Subject: Proposed Silesia Properties, L.P. Permit No. WQ0015835001

I am submitting these comments on behalf of the Greater Edwards Aquifer Alliance regarding the Texas Land Application Permit (WQ0015835001) proposed for Silesia Properties, LP. The propose permit would authorize wastewater treatment and subsurface drip dispersal system disposal for 0.365 million gallons per day into the Honey Creek watershed upstream of the Honey Creek State Natural Area.

Figure 9. Wetlands

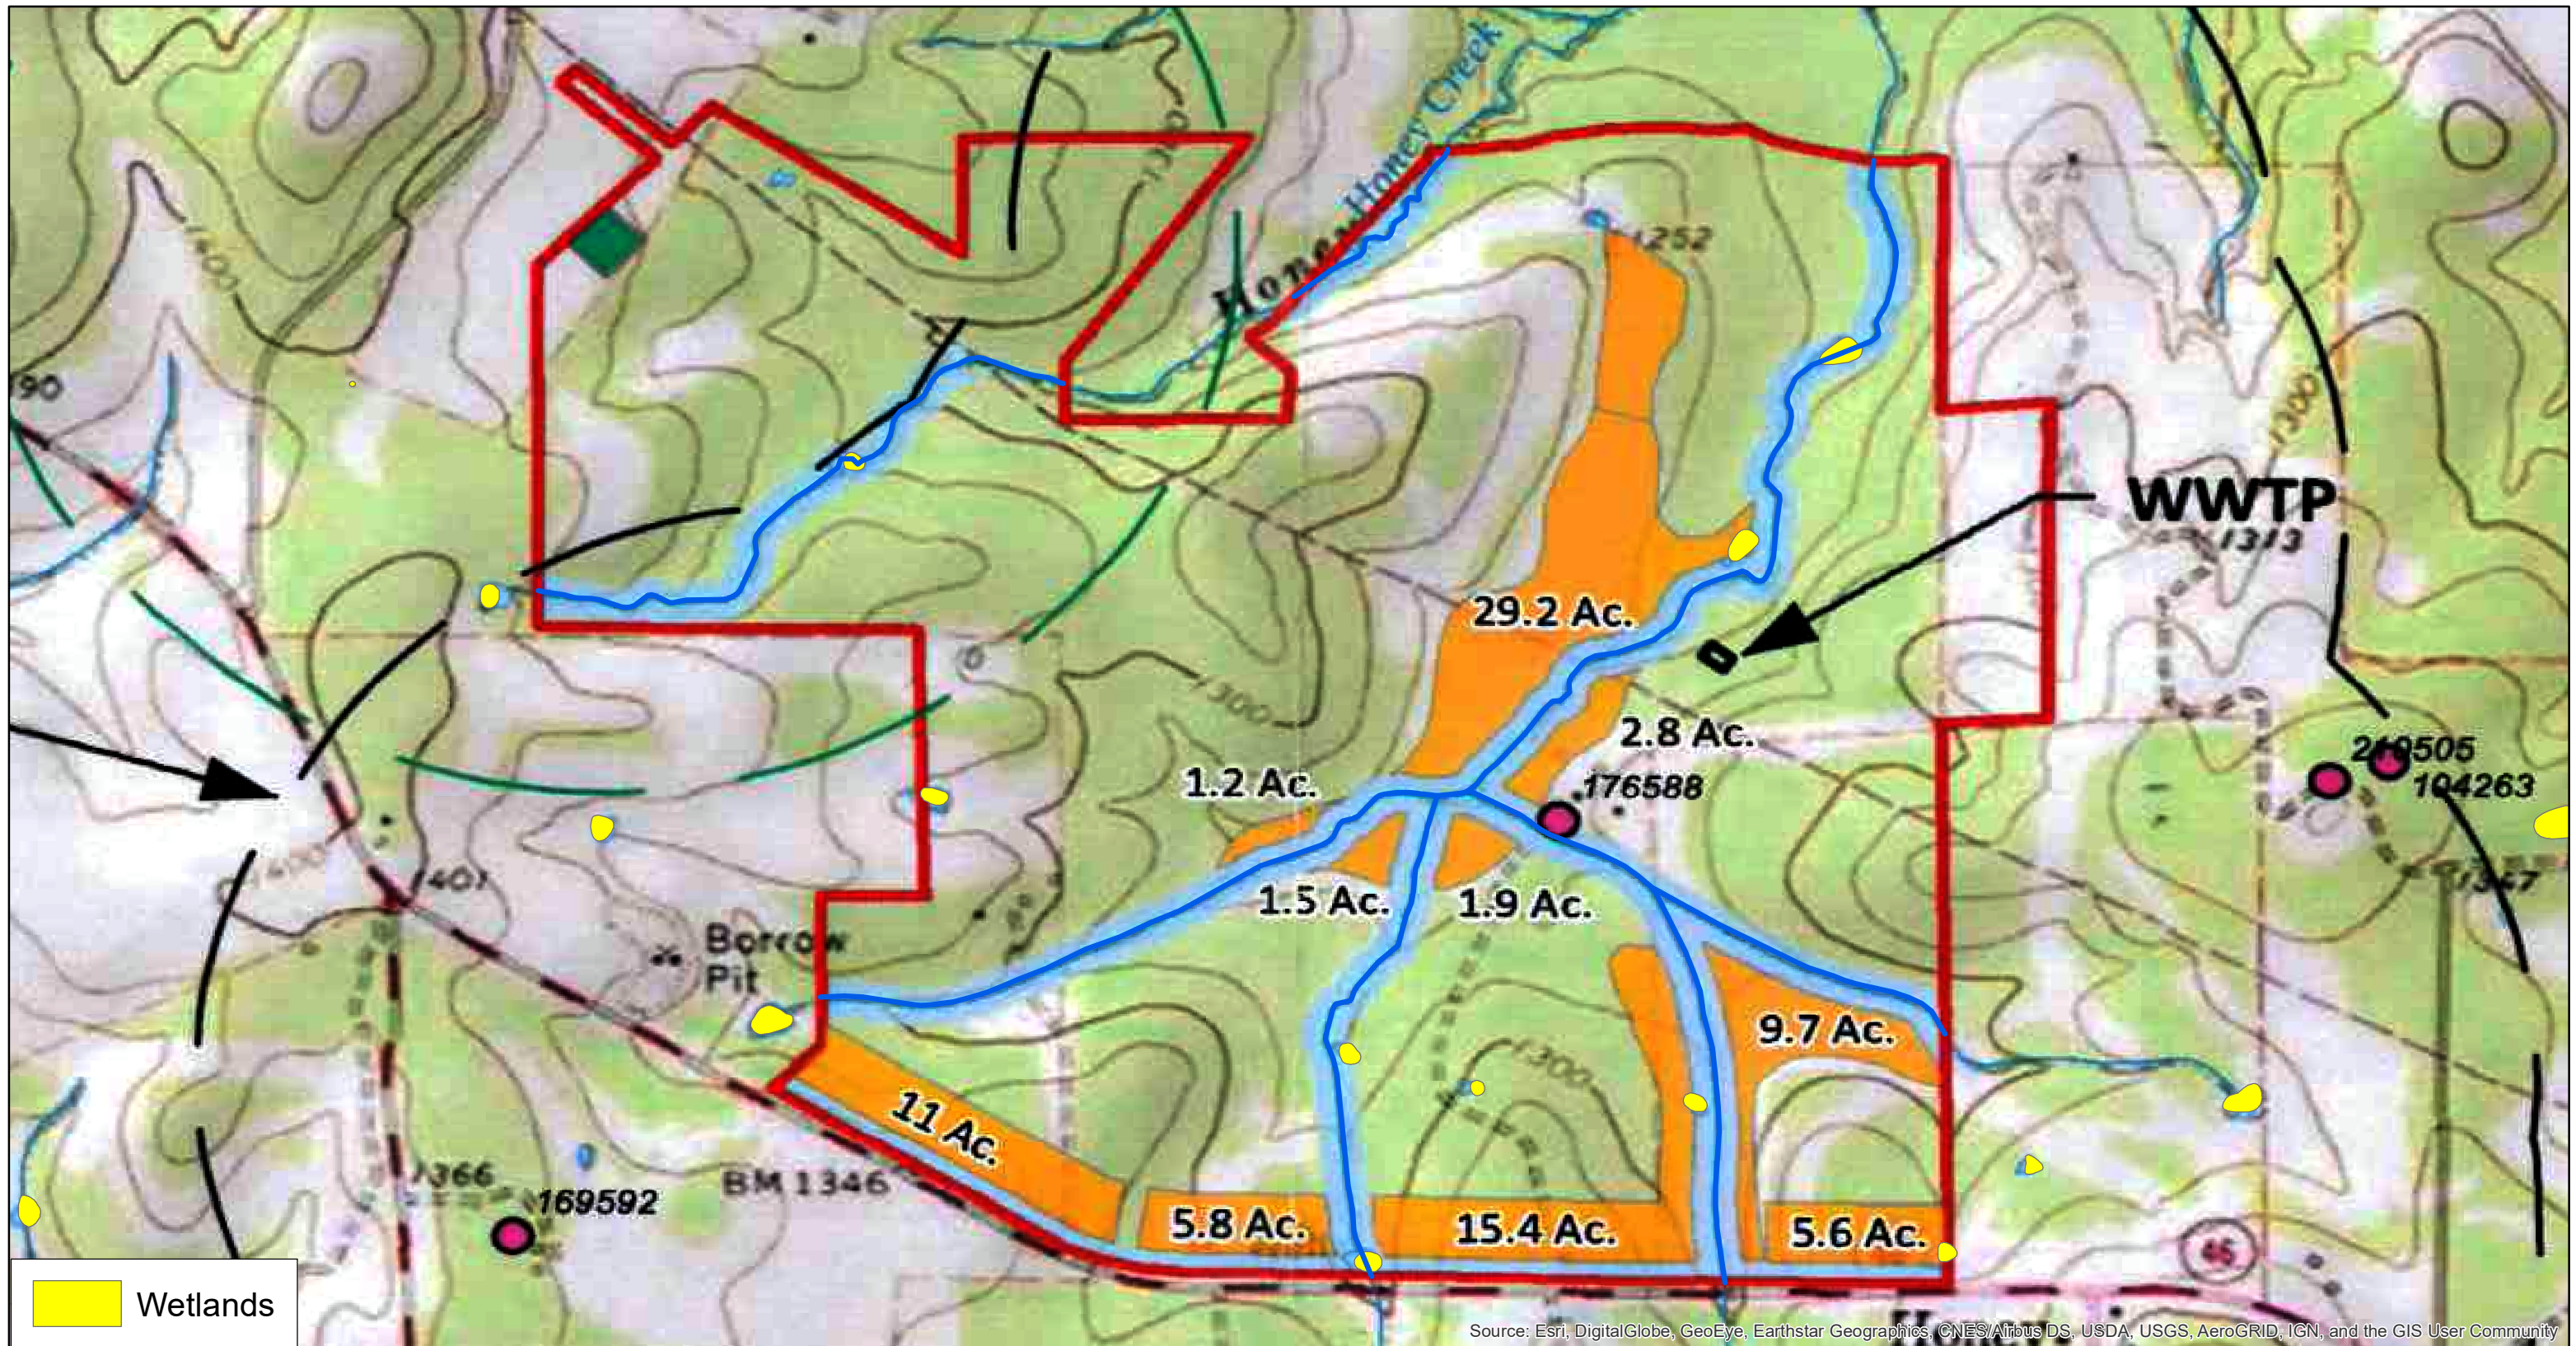
The database of Texas wetland areas includes eight freshwater ponds and one freshwater emergent wetland within Honey Creek Ranch, as shown on Figure 9.¹⁰ Three of these features are within, adjacent to, or downstream from proposed wastewater effluent disposal areas. The proposed permit fails to protect these sensitive wetland features.
